Town of Medway
DESIGN REVIEW COMMITTEE
155 Village Street, Medway MA 02053
(508) 533-3291

DRC Meeting Minutes: December 16, 2019
Medway Public Library

RIGHT SIDE ELEVATION
SCALE: 3/16" = 1'-0"

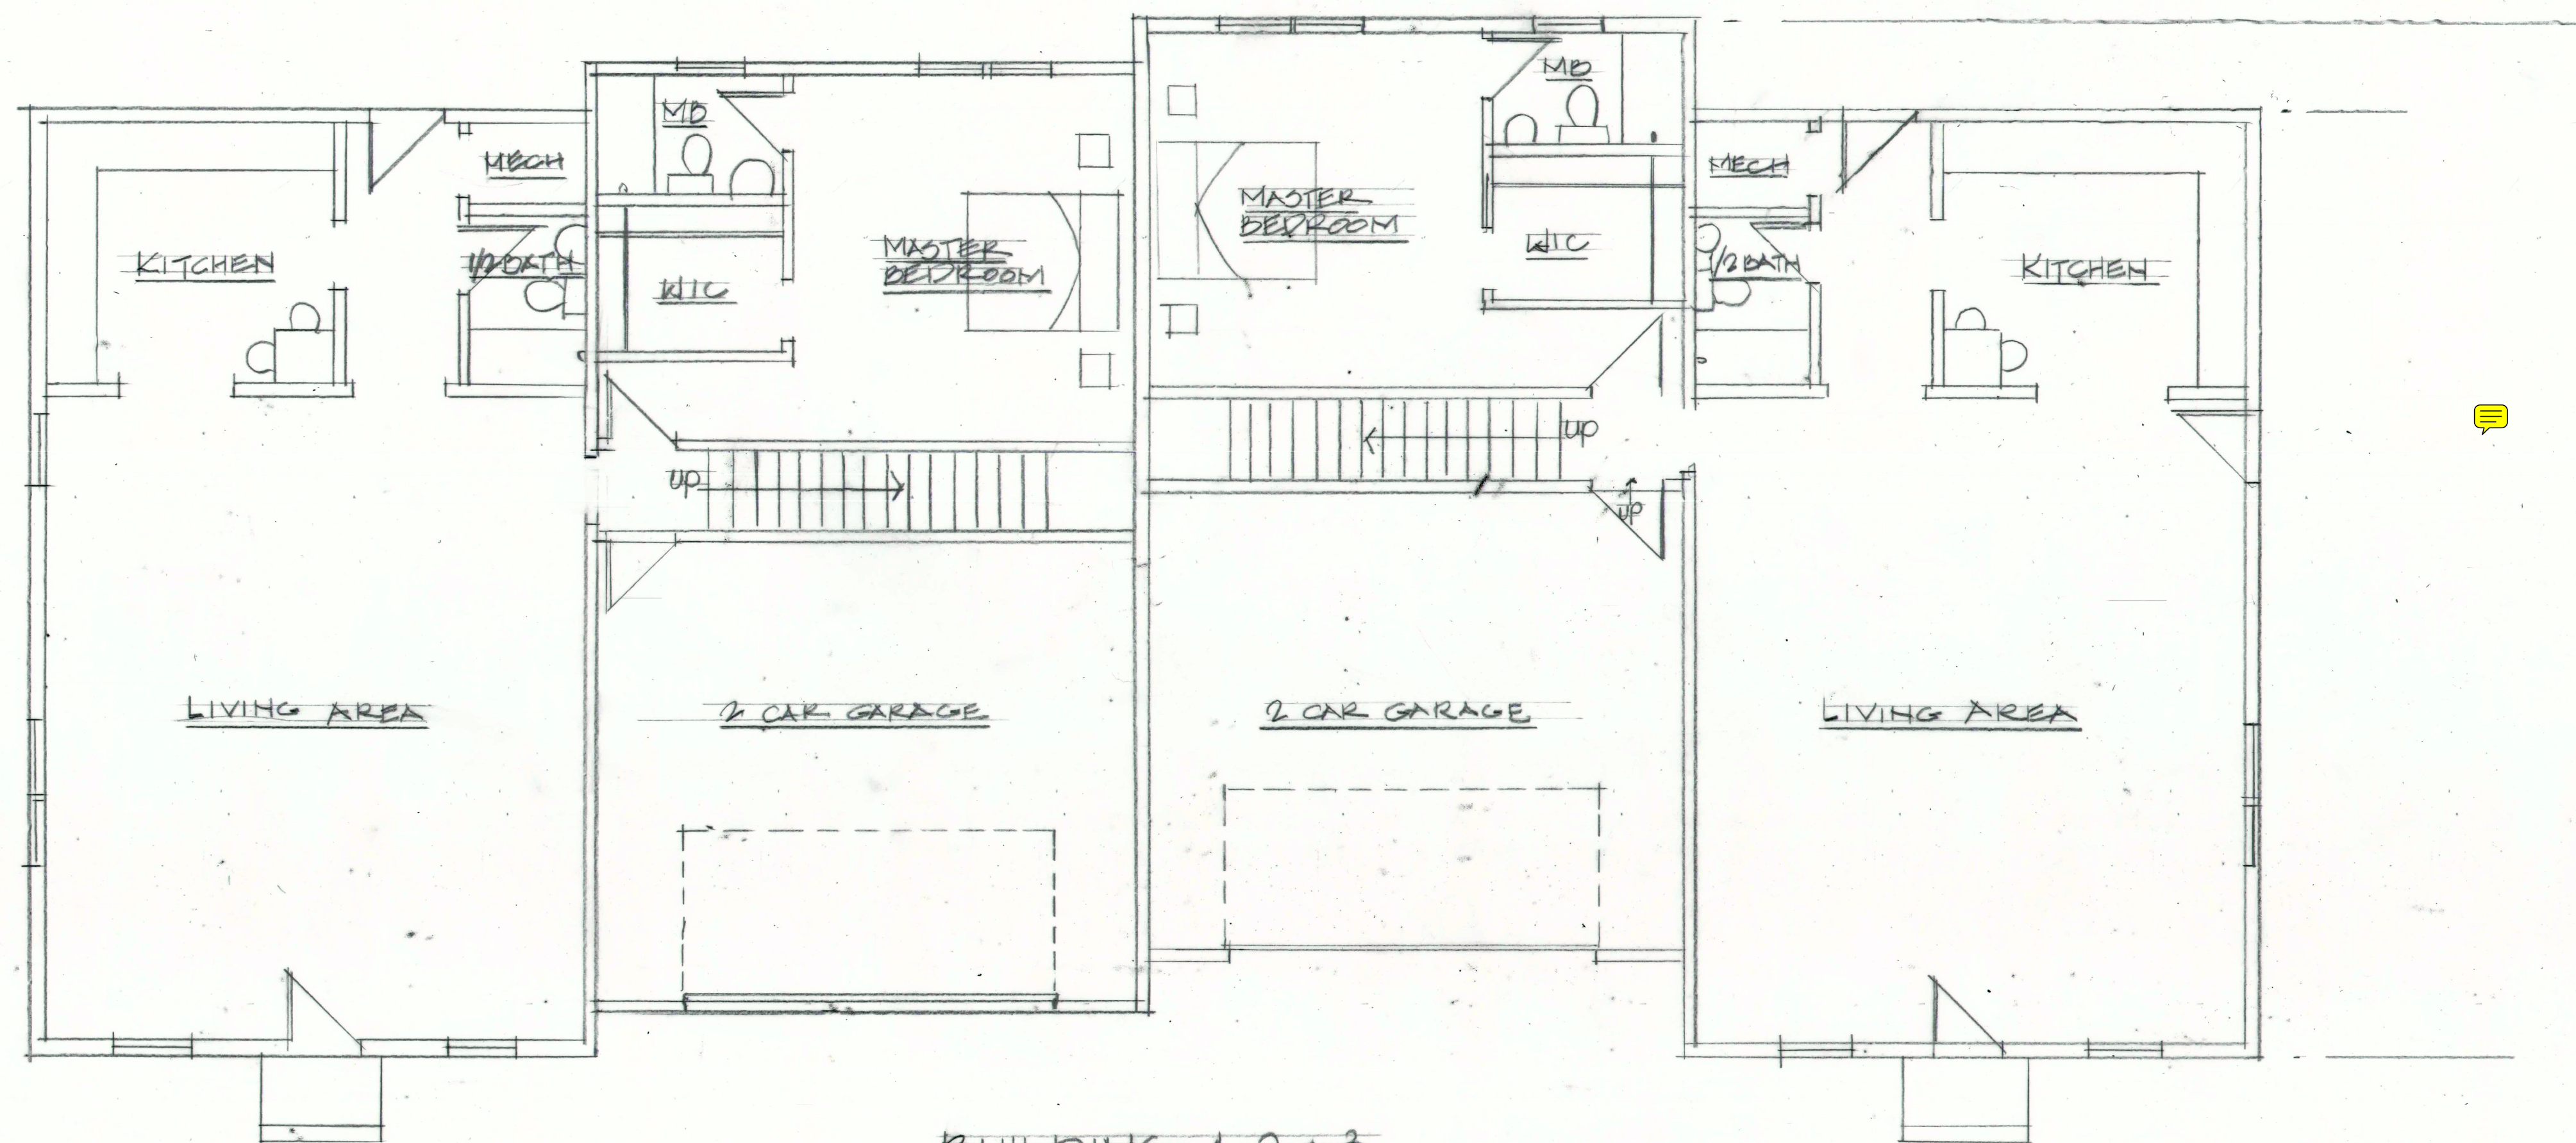
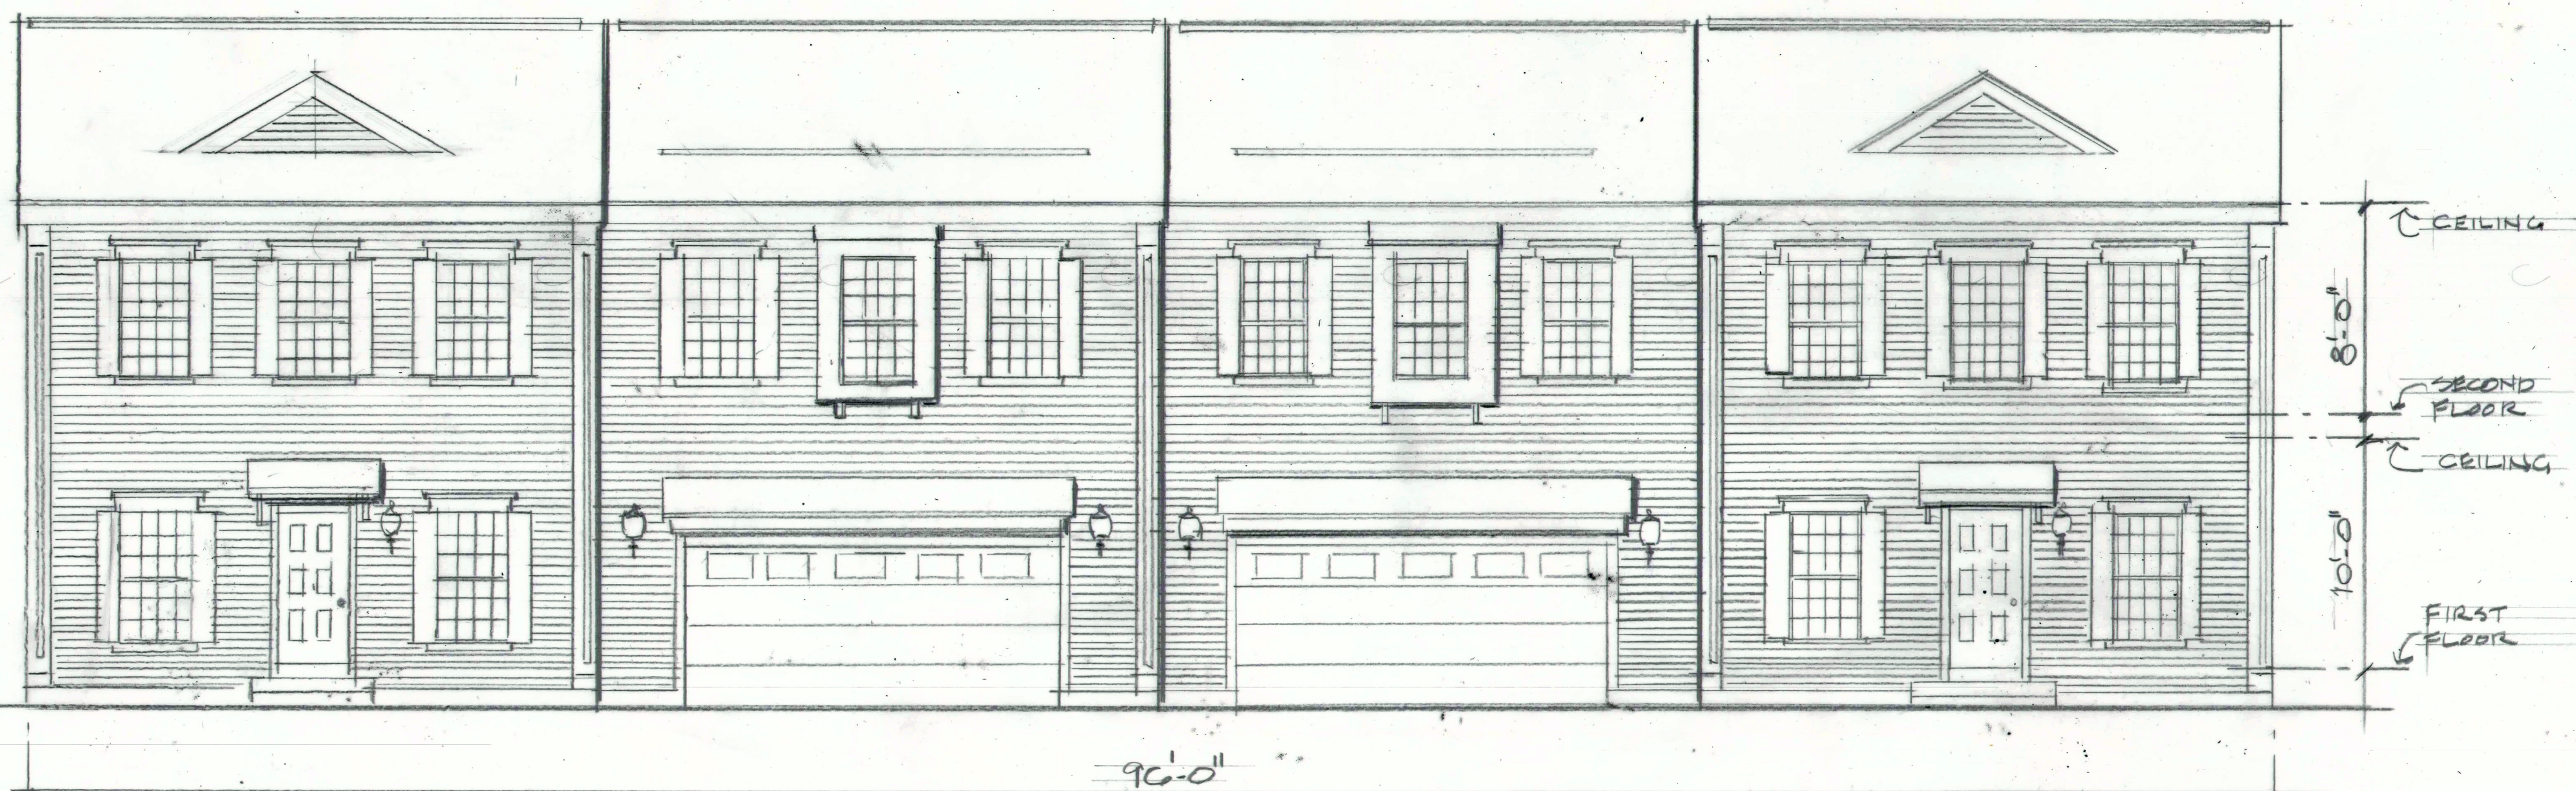
- The submitted rendering **(See Attached)** showed 4 duplex units in front and one triplex building. Members liked the revised building elevations as presented. There will be a granite wall along the front of the site at Village Street. A sign will hang off of the granite posts. Reclaimed granite will be set in the ground with 12" of exposure. A 4"x8" cap will run across the length of the wall.
- There are no trees around the 1st unit but trees will be included between the 2nd and 3rd buildings, and the trees on the rest of the property will be saved. Mr. Rucki requested

- Scottish thistle color was favored for building #1, silver gray for building #2, pebble stone clay for building #3, and white for the fourth building. White will be used for existing structure and the triplex building will use one of the noted three duplex colors with all three units being the same color.

Hi Susan I just sent over the revised triple .We had worked over the weekend reviewing the other duplexes with various styles .We were unable to make various changes that would be acceptable to us and to the DRC. The Architect suggested that I was trying to put too many styles of homes for a small development and suggested that we use the row house style for the first 3 duplexes and the triple. We are able to maintain consistency in style but we are able to move each section of the duplex to eliminate the massing which has been a major concern. Using various colors on siding and door will help with this as well. We will have the duplex rendering and plan view of layout on Monday. Have a nice few days off
